CNL-13-126

Browns Ferry Nuclear Plant Units 1, 2, and 3
Renewed Facility Operating License Nos. DPR-33, DPR-52, and DPR-68
NRC Docket Nos. 50-259, 50-260, and 50-296

Subject: Browns Ferry Nuclear Plant, Units 1, 2, and 3 - Proposed Technical Specification Change To Revise The Leakage Rate Through MSIVs - TS-485

BFN Primary "ALT" Pathway from Main Steam Lines to Condenser

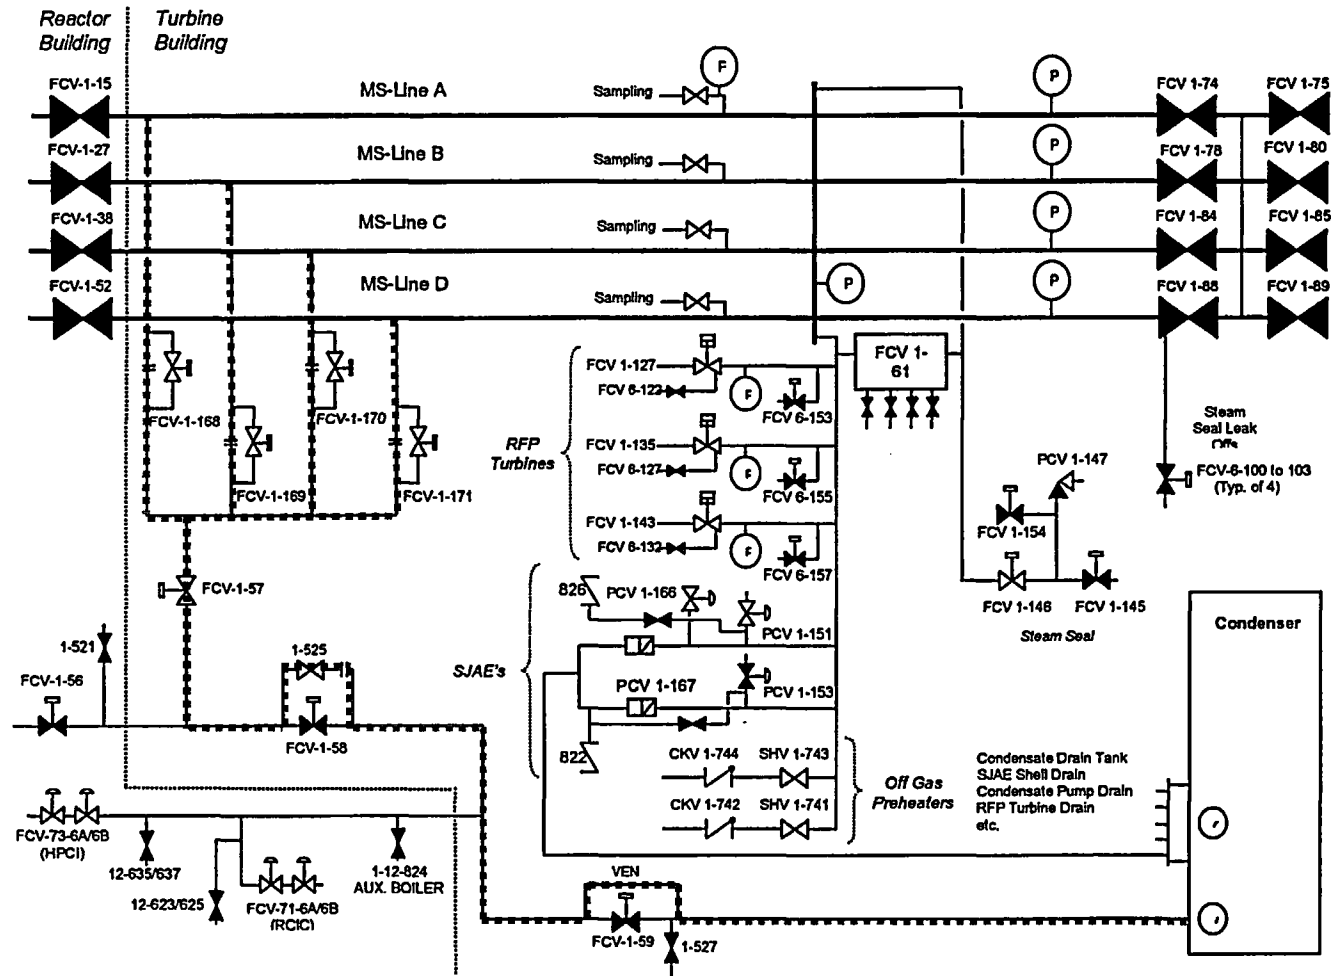
TVA proposes to continue to utilize the main steam drain lines to preferentially direct MSIV leakage to the main condenser. However, to resolve issues identified in the 10 CFR 50.9(b) notification associated with the ALT Pathways, the primary ALT Pathway (Figure 1) will be defined as the passive pathway through the orifice bypass lines around each of the main steam drain lines, through open valve FCV-1-57, through the orifice bypass line around valve FCV-1-58, and finally through a non-orifice bypass line around valve FCV-1-59 to the condenser. To support the use of this passive pathway, the dose analysis has been re-performed assuming reduced MSIV leakage rates of 60 scfh maximum through each MSIV and 85 scfh for the combined leakage rate for all four main steam lines. The secondary ALT Pathway (Figure 2) has now been defined as the

The primary ALT Pathway is based on the flow path through the orifice bypass lines around each of the main steam drain lines, through open valve FCV-1-57 (which will have its power removed), through the 0.1875-inch orifice bypass line around valve FCV-1-58 and the four inch bypass line around FCV-1-59 for those events taking credit for the availability of the ALT Pathway to the condenser. The primary flow path from the MSIVs to the condenser continues to be passive, requiring no operator actions or valve positions to change to establish the pathway. This primary flow path consists of the following:

- Four outboard MSIVs through 24- inch lines connecting to two-inch drain lines from each MSIV.
- Four two-inch bypass lines, that contain 0.25-inch orifices (around valves FCV-1-168, FCV-1-169, FCV-1-170 and FCV-1-171), connecting to a three-inch header.
- The three-inch header through normally open, with power removed, valve FCV-1-57 to a three-inch tee.
- The three-inch tee through a one-inch bypass line (around the normally closed valve FCV-1-58) that has a 0.1875-inch orifice and a normally open manual blowdown valve (BOV)-525.
- A four-inch bypass line (around normally closed valve FCV-1-59) to the condenser.

BFN Secondary "ALT" Pathway from Main Steam Lines to Condenser

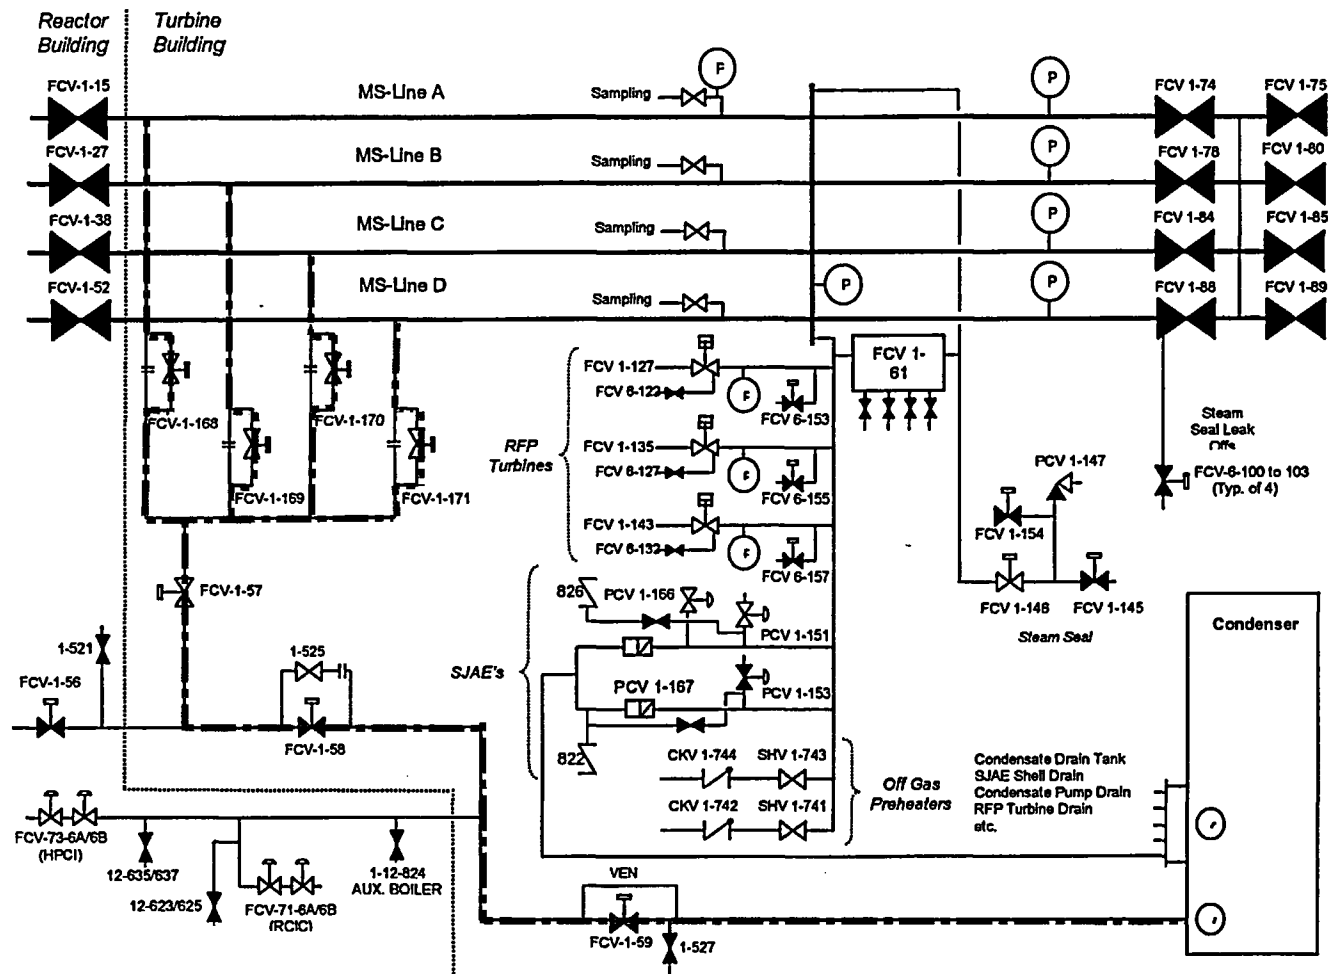
pathway through the main steam drain lines and through open valves FCV-1-57, FCV-1-58, and FCV-1-59 to the condenser.

In the unlikely event the primary flow path is not available, and consistent with the guidance provided in NEDC-31858P, a secondary flow path is provided (although not with orifice flow). The secondary flow path is through normally open valves FCV-1-168, FCV-1-169, FCV-1-170, and FCV-1-171, and continues through valves FCV-1-57, FCV-1-58, and FCV-1-59 to the main condenser.

MSIV Seismic Verification Walkdown Boundary

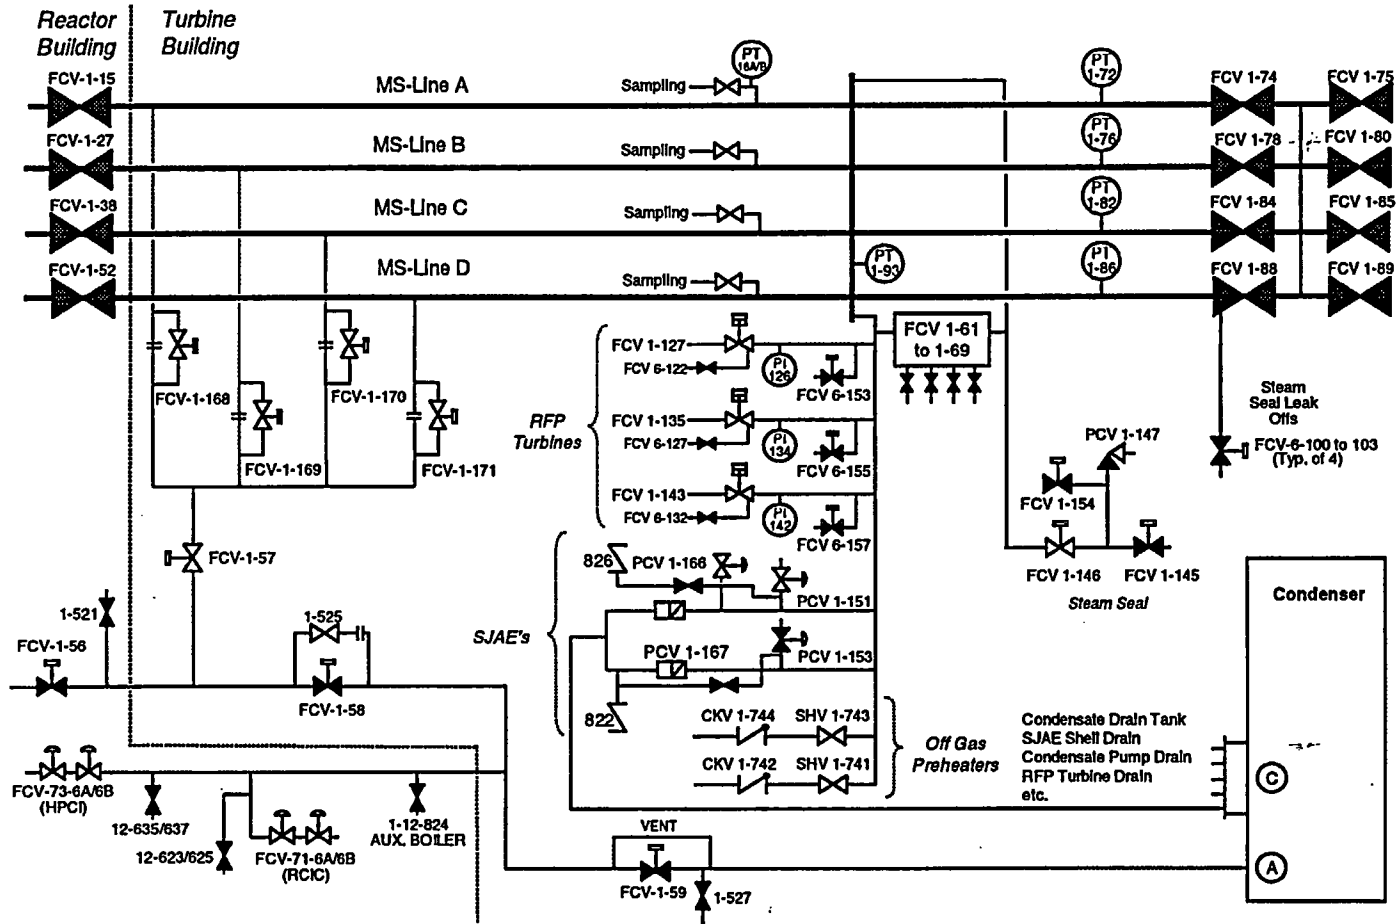
The MSIV Seismic Verification Walkdown Boundary (Figure 3) provides a flow diagram schematic that shows the ALT Pathway from the MSIVs to the condenser and the boundary valves associated with the ALT Pathway for BFN, Units 1, 2, and 3. As discussed in NEDC-31858P, "BWROG Report for Increasing MSIV Leakage Rate Limits and Elimination of Leakage Control Systems," the ALT Pathway establishes a seismically rugged route to contain and direct leakage from the MSIVs to the condenser following a design basis LOCA.

As previously noted, Figure 3 provides a flow diagram that shows the ALT leakage pathway from the MSIVs to the condenser, and the boundary valves. All boundary valves are either closed during normal system operation or fail closed upon loss of power, loss of control air, or hydraulic pressure or close upon line depressurization. All of the boundary valves fall into one of the following categories:
